Town of Arlington, MA Redevelopment Board

Agenda & Meeting Notice July 14, 2025

To: Arlington Redevelopment Board
From: Claire V. Ricker, AICP Secretary Ex-Officio
Subject: Site Plan Review, 225 Broadway, Docket #3857
Date: July 10, 2025

SD1.1

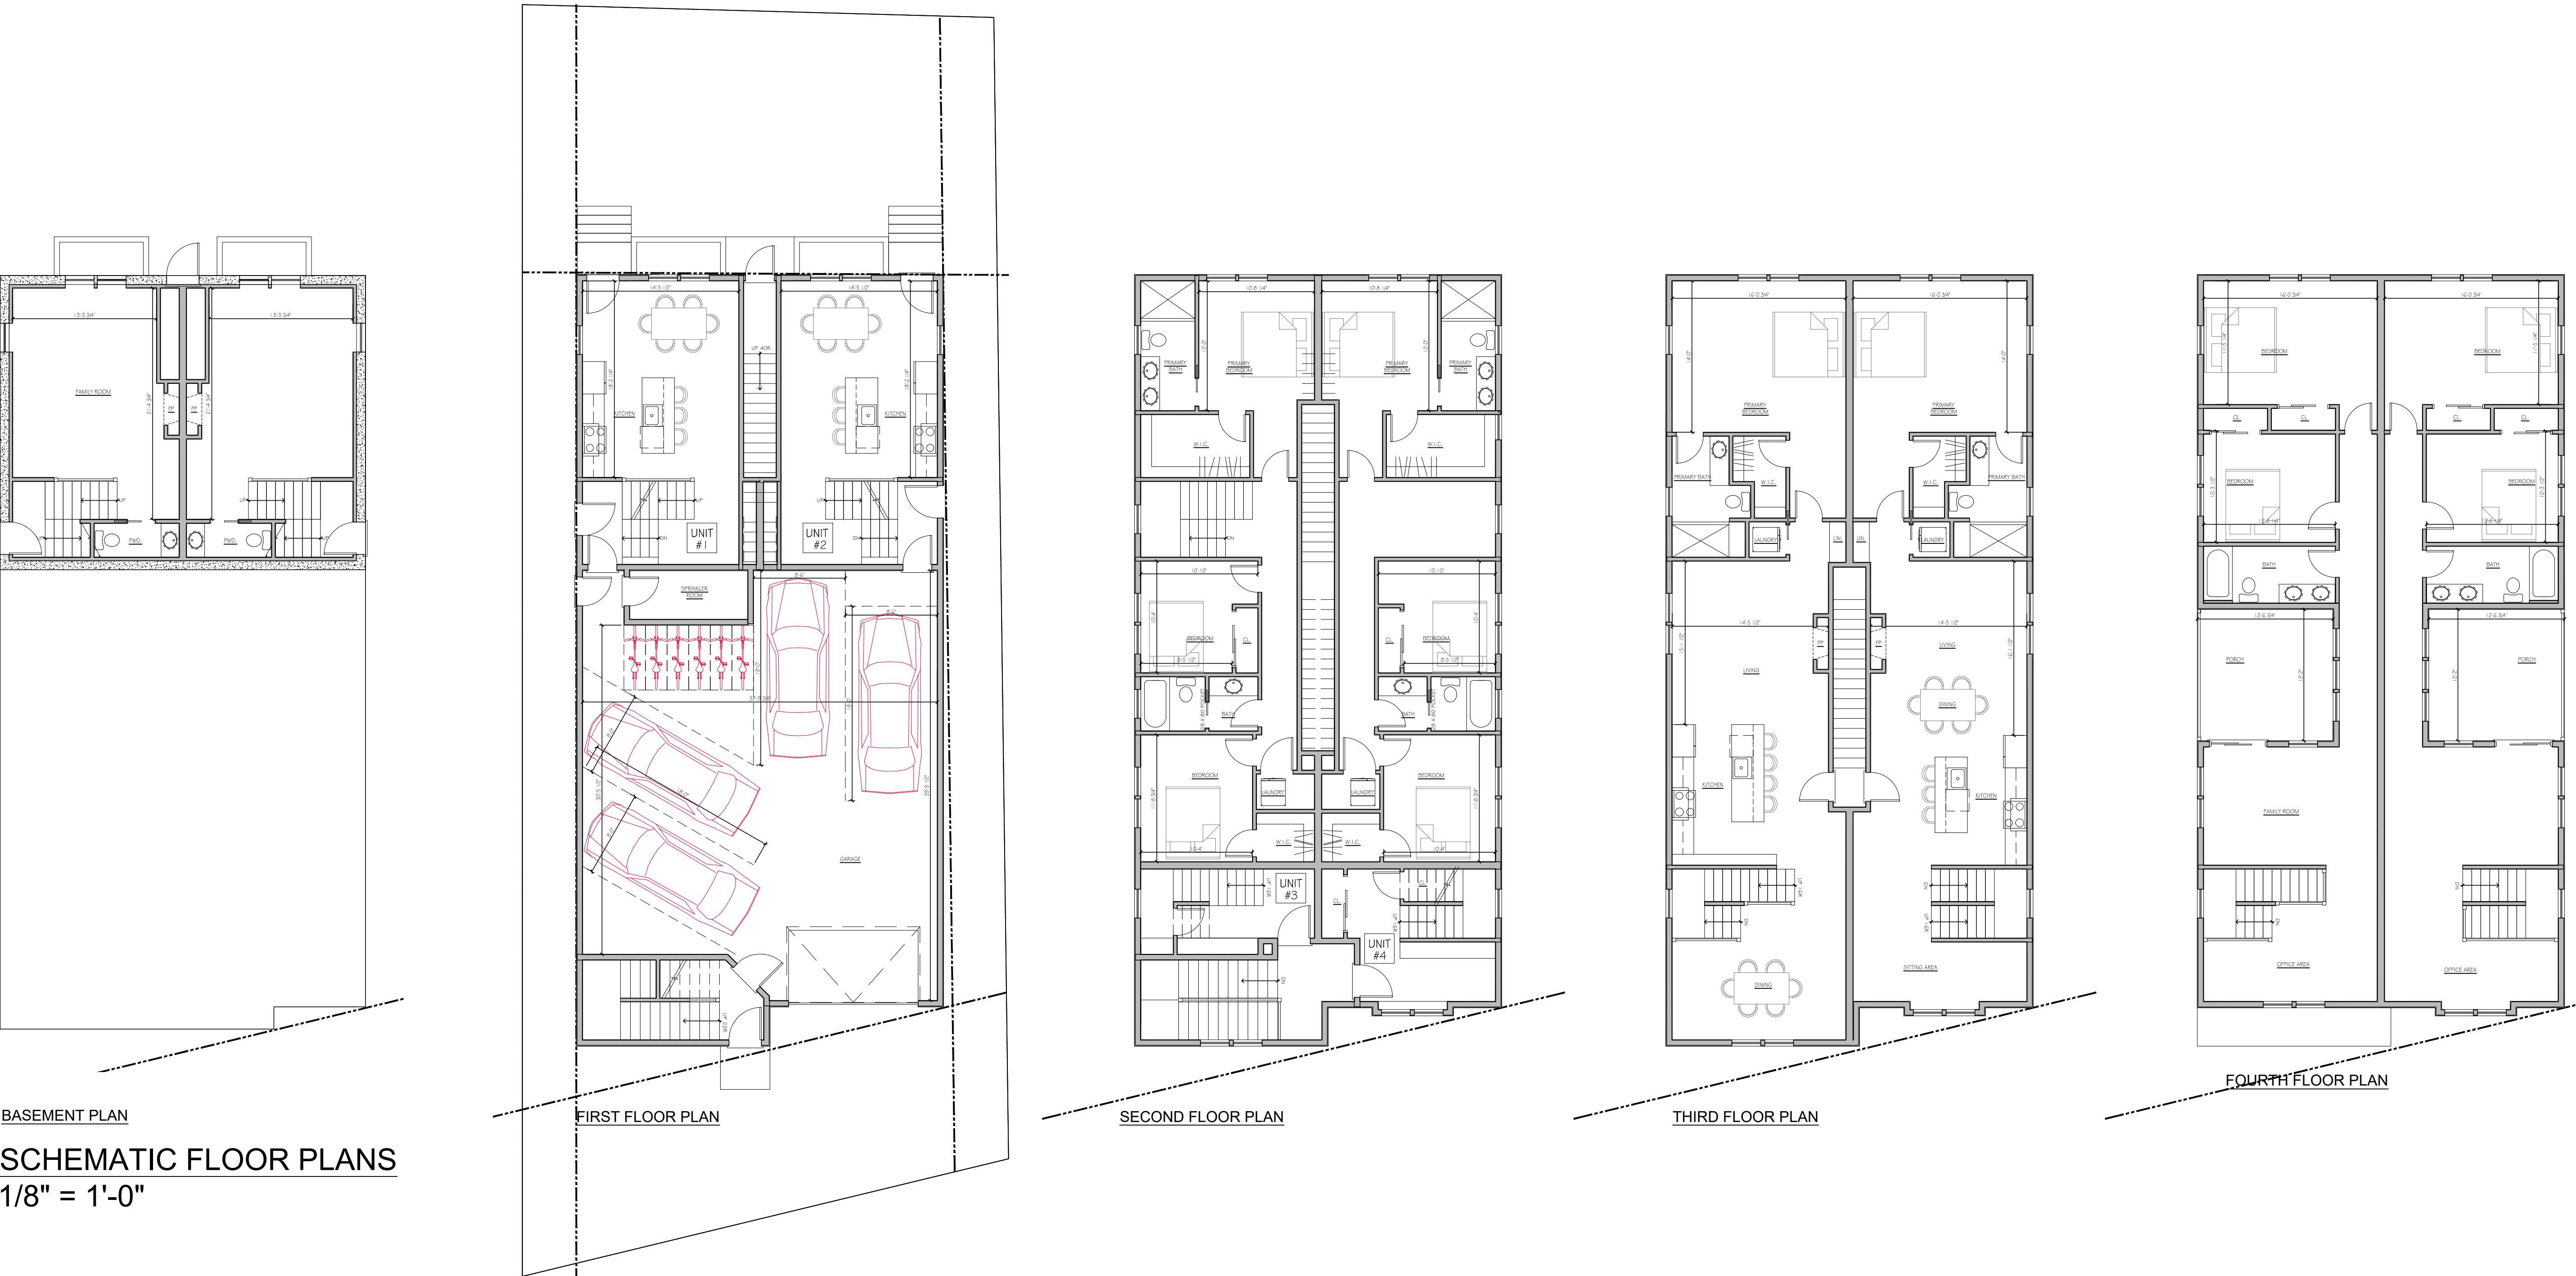
Equipment for heating and cooling is not called out on the roof or site plan. The Board may consider asking for updated plans with the locations of mechanical equipment.

LANDSCAPE PLAN

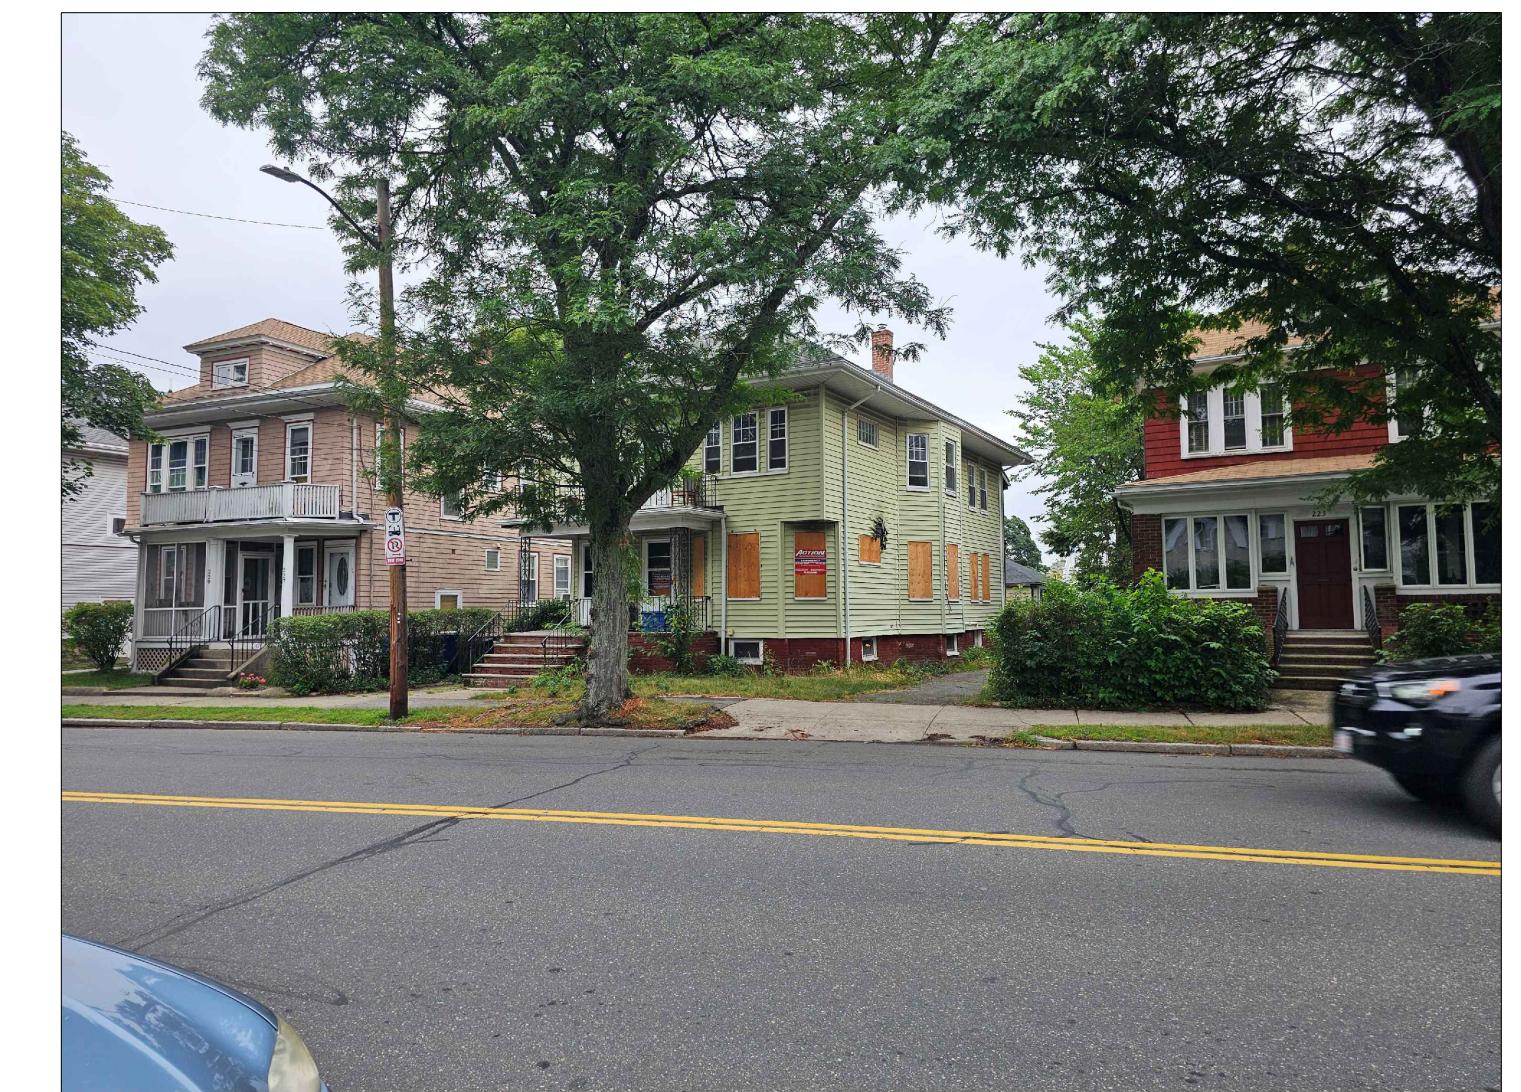
Landscaped open space is proposed for the front and rear yards. The front setback will be enhanced with plantings and pavers including two trees. The rear setback includes two patios for the use of tenants designed to encourage social interaction between neighbors of the development. The patios will be enhanced by landscaped lawn areas that extend around the sides of the building with pervious bluestone pavers.

The proposed site plan shows trash and recycling receptacles adjacent to the building on the Broadway façade behind a fence and gate with landscaped screening.
